## CITY of NOVI CITY COUNCIL

Agenda Item 6  
August 24, 2015

**SUBJECT:** Consideration of a request from Michael and Rachael O'Sullivan for a variance from Section 11-216(e)(8) and Section 11-256(f) of the Design and Construction Standards, which allows a maximum driveway slope of 10% and a maximum sidewalk cross slope of 2%, to allow the applicant to maintain the slopes as-constructed for the construction of a home at 21379 Equestrian Trail (parcel 22-32-401-074).

FF	973.77
TOF	972.60
GF	971.93
FG	971.60
BF	964.10
TOP OF FOOTING	963.77 (8'-10")
FG	971.60
CB	968.60

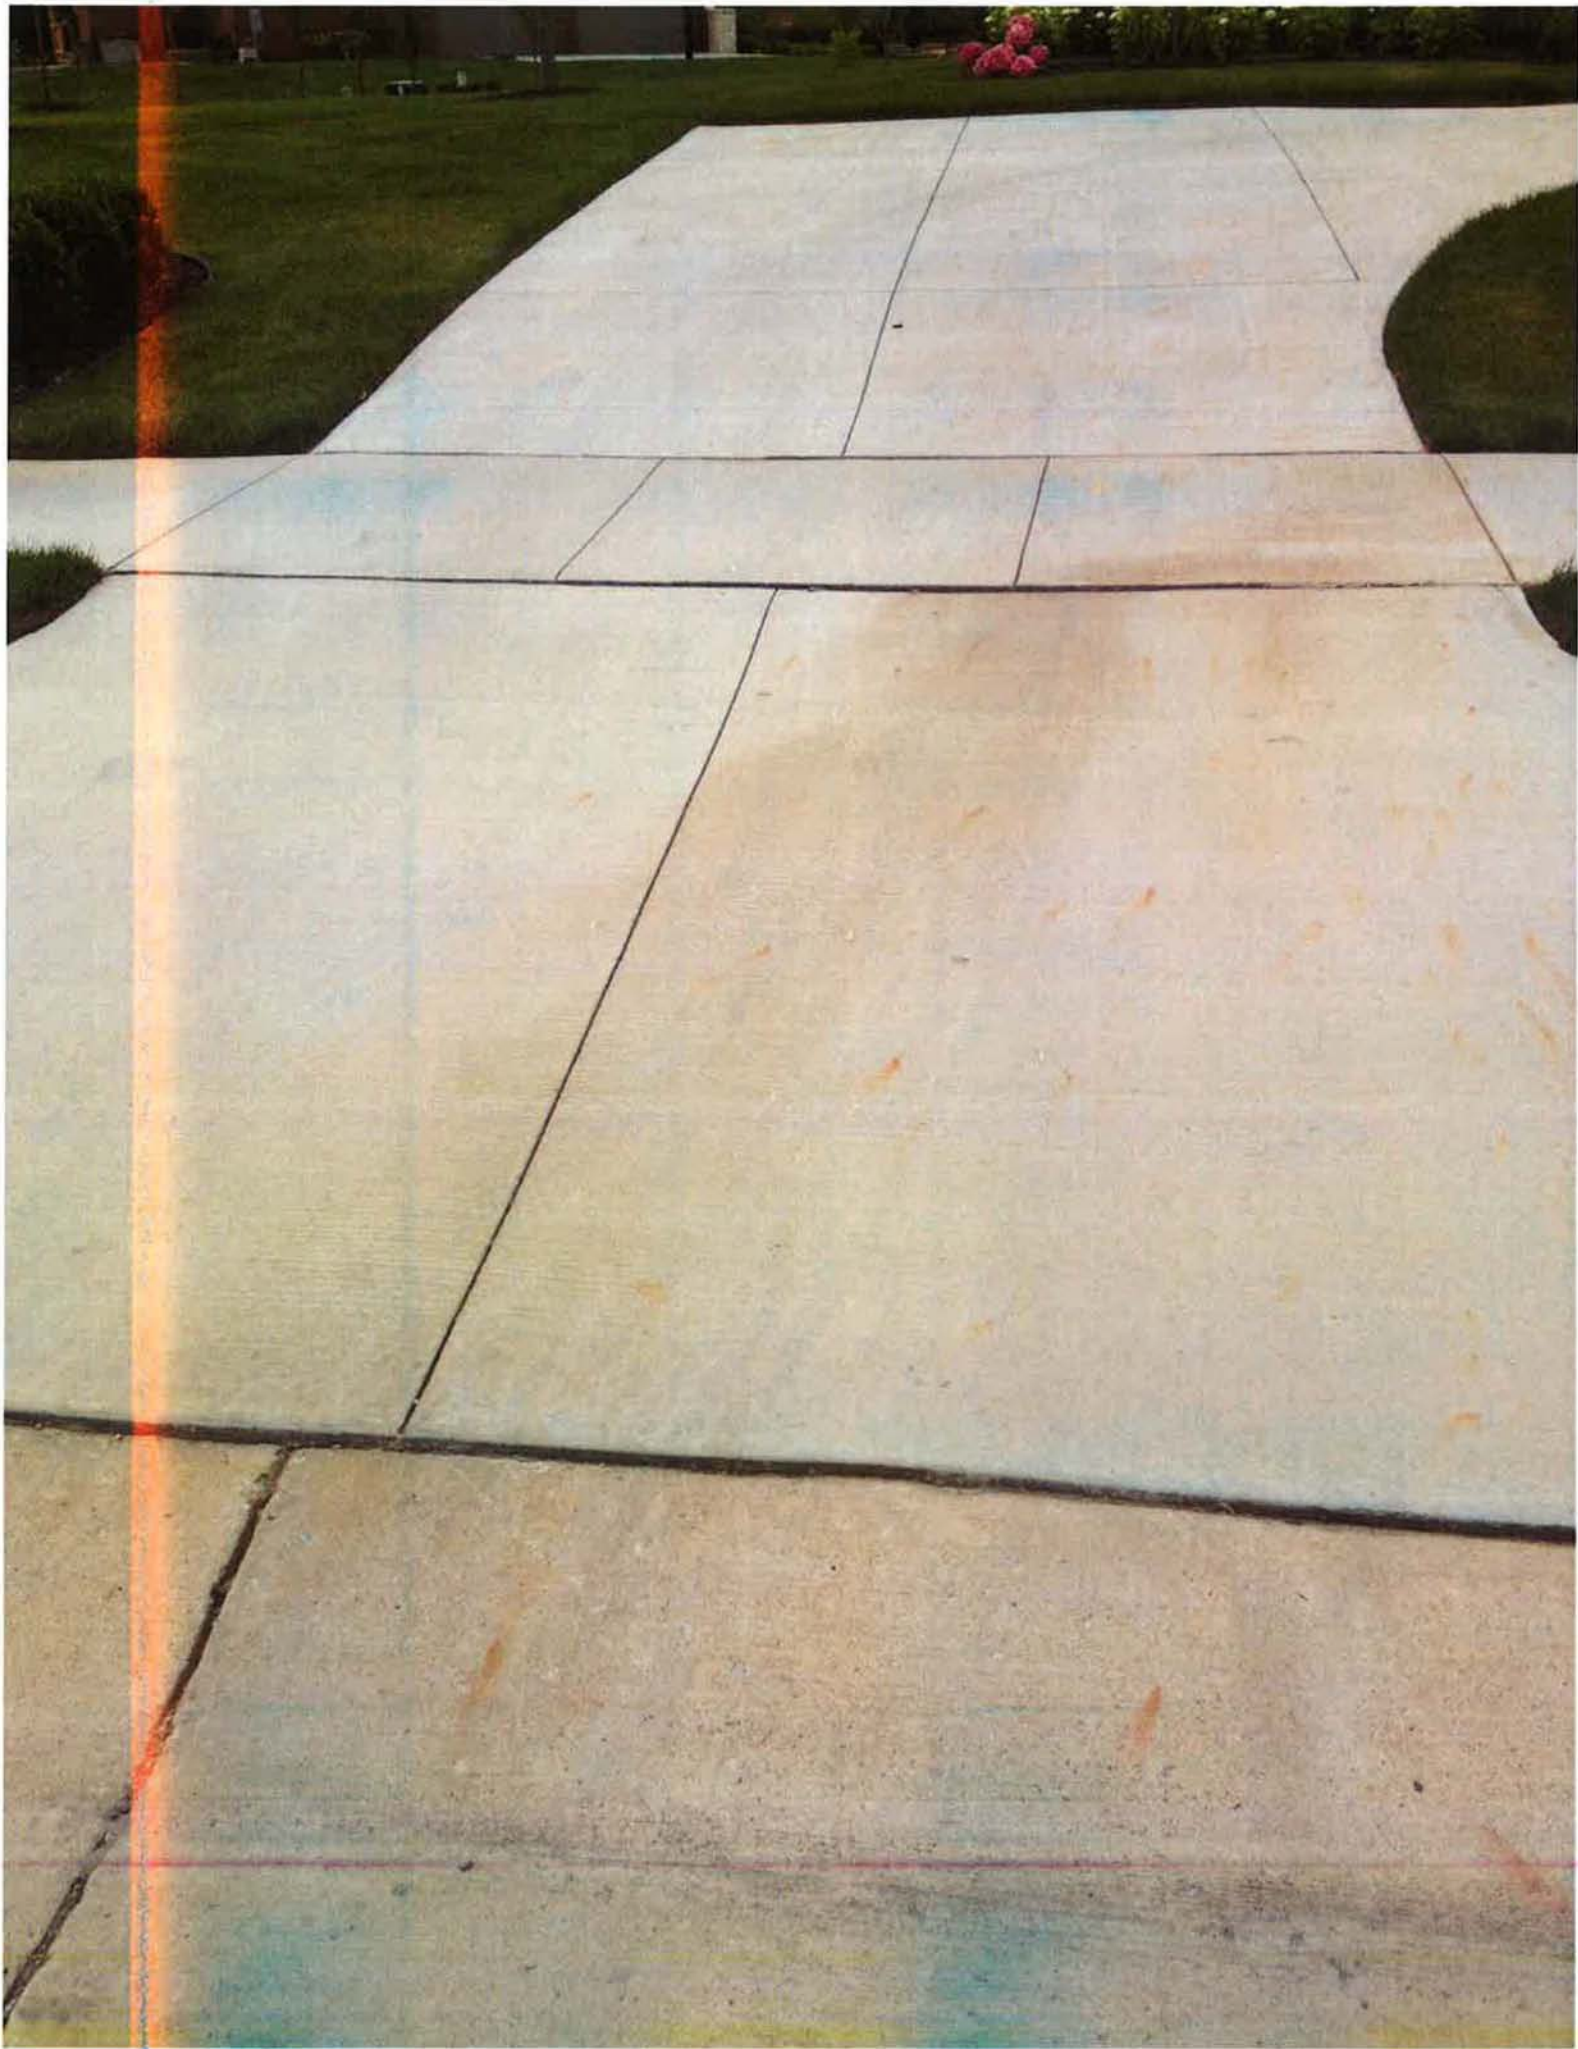
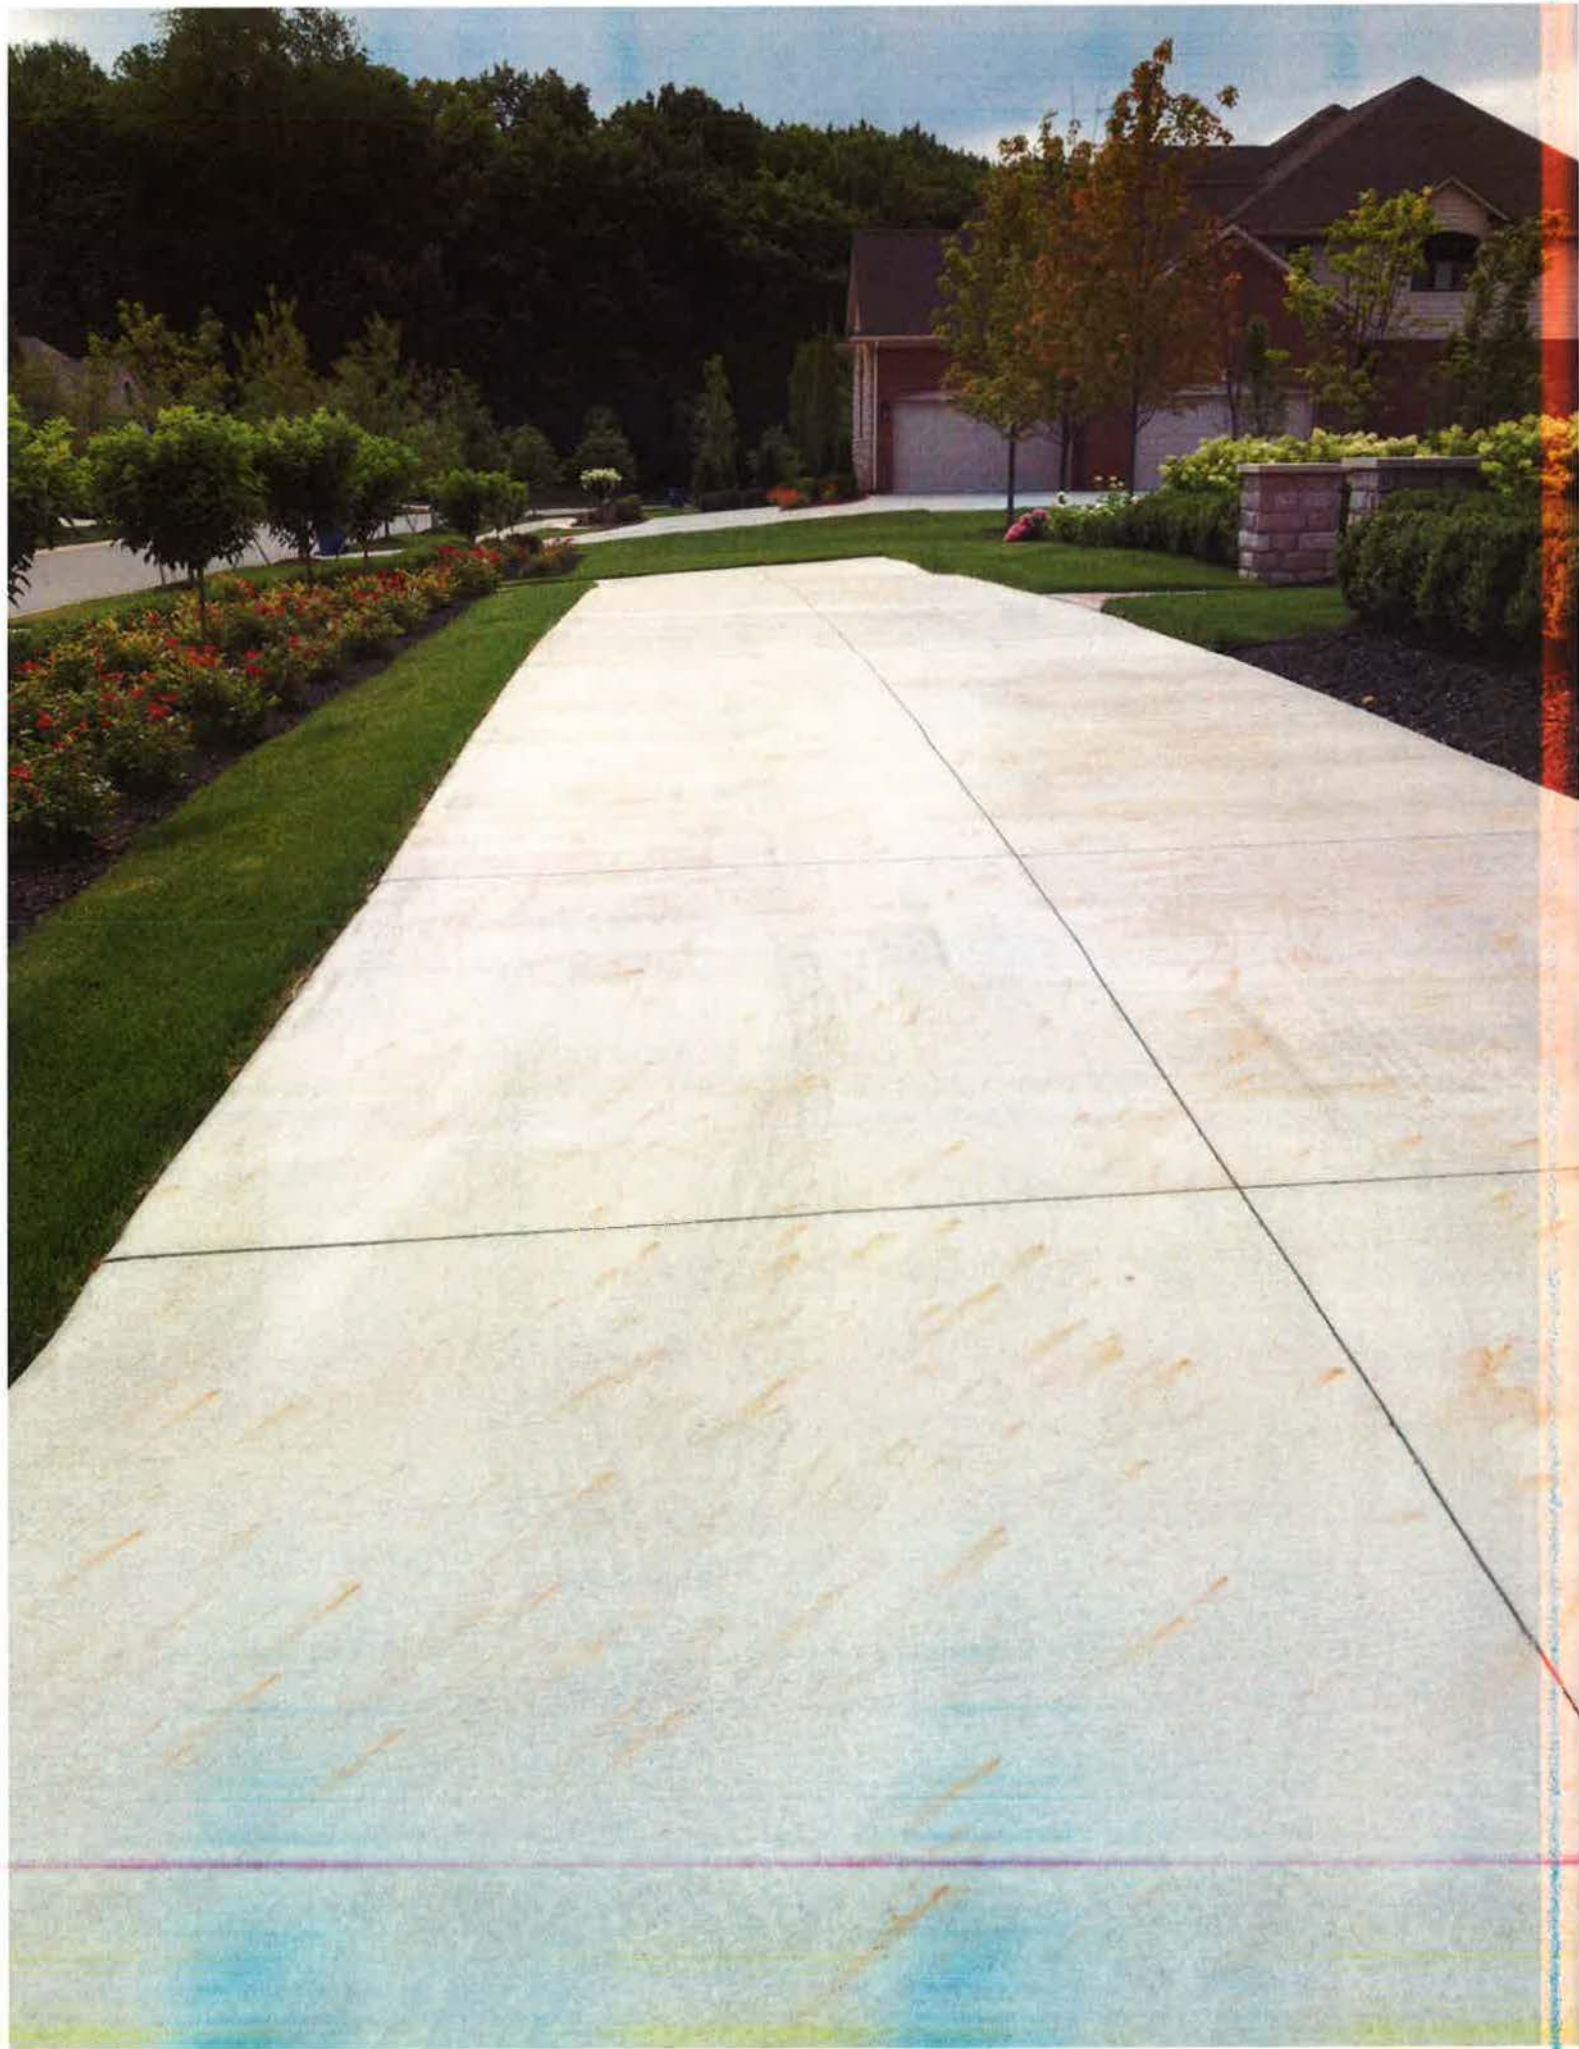
The ordinance sets a maximum running slope for a driveway at 10%, whereas the as-constructed slope on the easterly driveway is 11-14%. The applicant said that they changed the slope in the field because of a manhole that was too low. However, the manhole could have been adjusted to better accommodate the slope shown on the approved plan. Since the driveway is located on private property and the property owner is willing to accept the condition, staff can support this part of the variance request.

The Engineering Design standards set the maximum cross-slope of a sidewalk at 2%, which is consistent with the Federal Americans with Disabilities Act (ADA) Standard, attached. The sidewalk cross slopes as constructed in the field exceed the 2% maximum in more than half the locations measured. Since Equestrian Trail is a private street, it would be the responsibility of the condominium owners to ultimately make the sidewalk cross slope compliant with ADA Standards, not the City. However, the review standard for the variance in Section 11-10 of the ordinance requires that "the granting of the variance will not be detrimental to public health, safety, or welfare..." The federal requirement for the sidewalk cross-slope is primarily intended to protect wheelchair users from becoming unstable. In this situation, the constructed cross slopes of 3-4% could pose a risk to sidewalk users in wheelchairs. The only remedy for the situation is to remove and replace several sections of sidewalk, which would be expensive for the applicant. However, the constructed sidewalk substantially deviates from the standard and poses safety concerns to a segment of the population. For these reasons, staff cannot recommend approval of this part of the variance request.

- Multiple areas of sidewalk + drive are > max allowed slopes (2% for walks; 10% for drives)

- Reference the copy of the red lined plan at the City

Approval of the request from Michael and Rachael O’Sullivan for a variance from Section 11-216(e)(8), which allows a maximum driveway slope of 10% to allow the applicant to maintain the driveway slopes as-constructed for the construction of a home at 21379 Equestrian Trail (parcel 22-32-401-074).

Denial of the request from Michael and Rachael O’Sullivan for a variance Section 11-256(f) of the Design and Construction Standards, which allows a maximum sidewalk cross slope of 2% for the following reasons:
